Liaison statement to SC29/WG11 on ISO/IEC 14496-4:2004/FPDAM 26 (ISO/IEC JTC 1/SC 29/WG 11 N9373)

SC34/WG2 reviewed ISO/IEC JTC1/SC29/WG11 N9373, Text of ISO/IEC 14496-4:2004/FPDAM 26 “Conformance levels and bitstreams for Open Font Format”. We recognized that the text is written for ISO/IEC 14496-4 conformance test of an OFF object embedded in MPEG-4 bitstream, or another conformance test of a MPEG-4 decoder to testify its features to deal the OFF object embedded in MPEG-4 bitstream, and it defines nothing for a generic OFF decoder or the structure of the embedded font objects (e.g. a decoder for TrueType font embedded in PDF (ISO 32000) document is out of scope of the text). Although it is focused to the utilization of OFF in MPEG-4 bitstream, there are a few points to be clarified. We provide the list of them in following.

Figure 1: ISO/IEC 14496-4/FPDAM 26 Conformance level

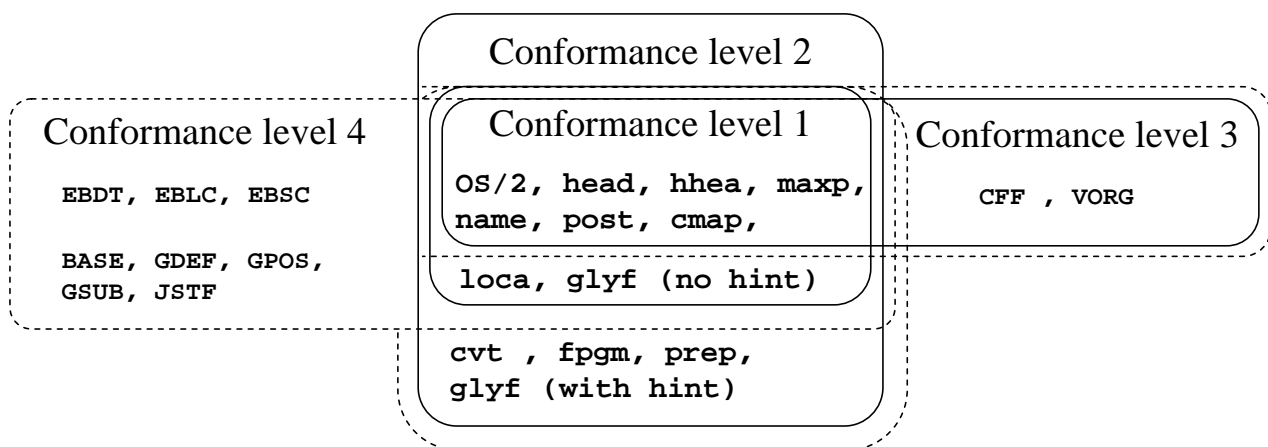
The word “conformance level” should be used when the conformance levels are designed in an inclusion relation. For example, a claim “decoder XXX conforms level 2” is expected, but a claim “decoder XXX conforms level 2 and 3” is not expected. Figure 1 is a Venn diagram illustration of the structure of 4 conformance levels described in 4.15.1. The conform level 1/2 and level 3 are in parallel. Separation of TrueType based conformance level and PostScript based conformance level would be easier to indicate the available features of a decoder.
